Title: TOP & POWER

Project: NUCLEO-XXXXXXX			
Size: A4	Reference: MB1136	Revision: C.3	
Date: 9/26/2014		Sheet: 1 of 4	life.augmented

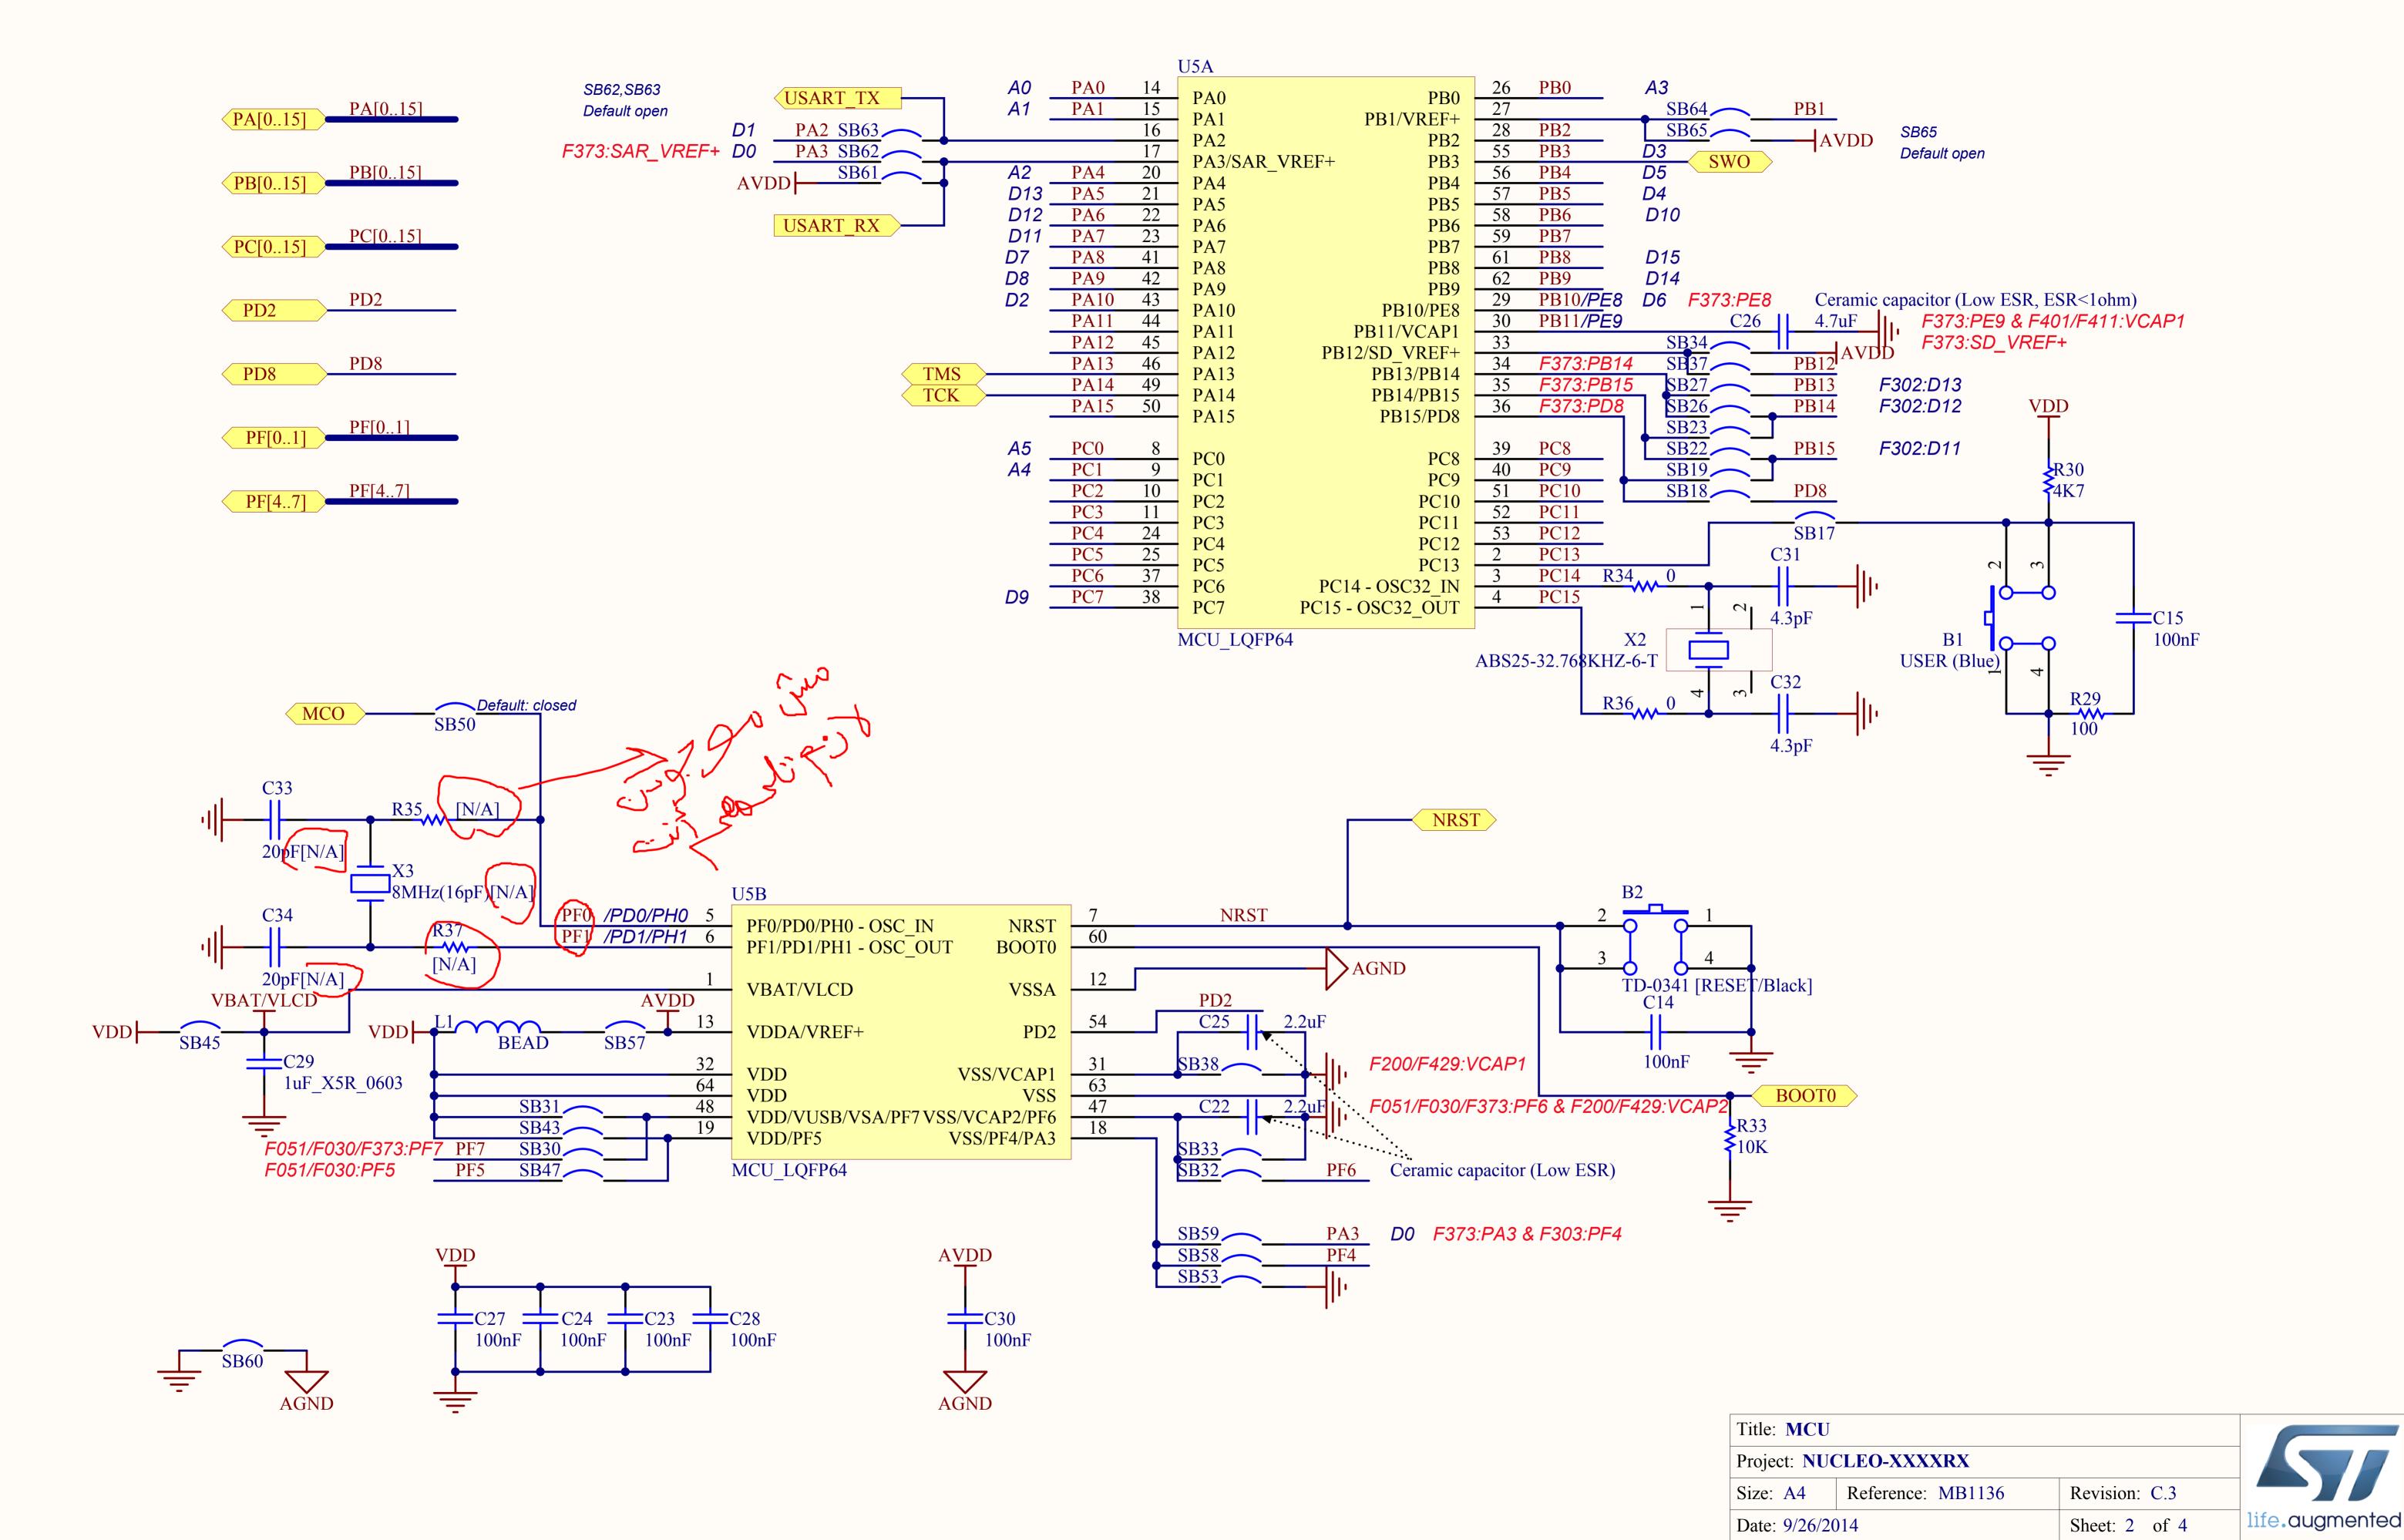
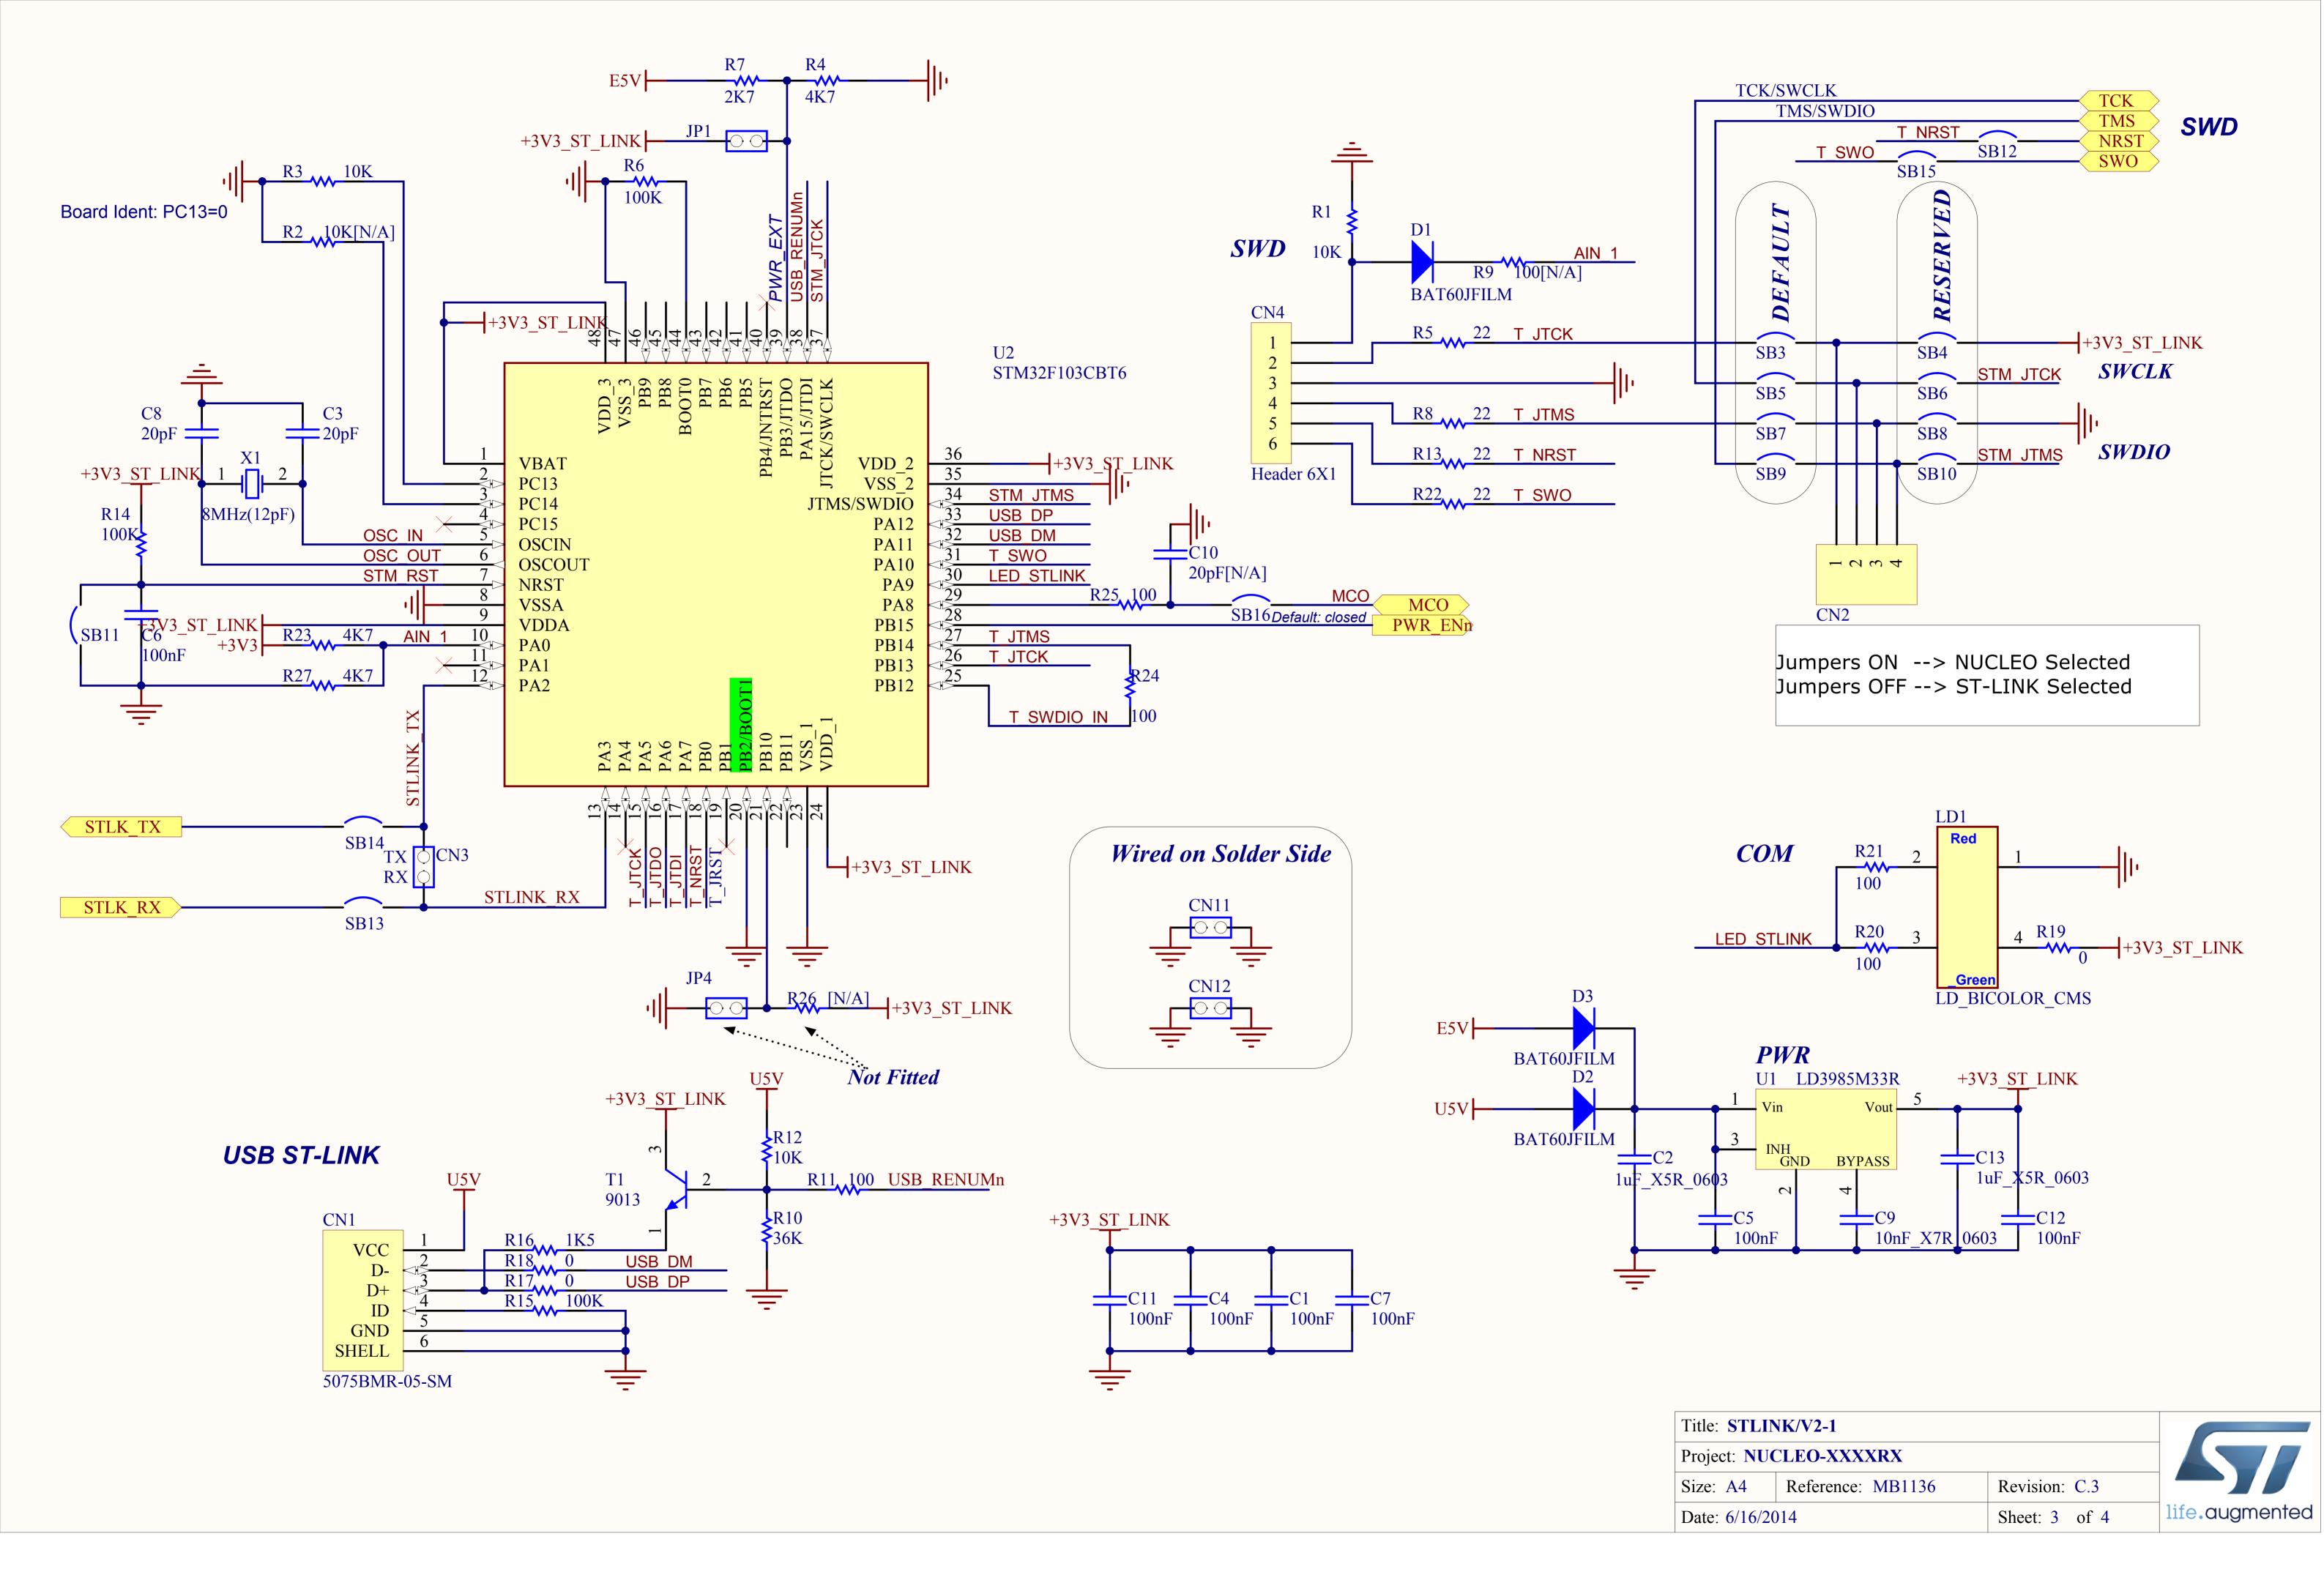
Note2: Remove [N/A] on R34, R36, C31, C32, X2 from C.1 to C.2

Note3: Add "default open" on SB48, SB49, SB55 from C.1 to C.2

Note4: Replace "default open" by "default closed" on SB16 & SB50 from C.1 to C.2

Note5: C31&C32 value changed from 10pF to 4.3pF to fit with new 32K crystal ABS25-32.768KHZ-6-T
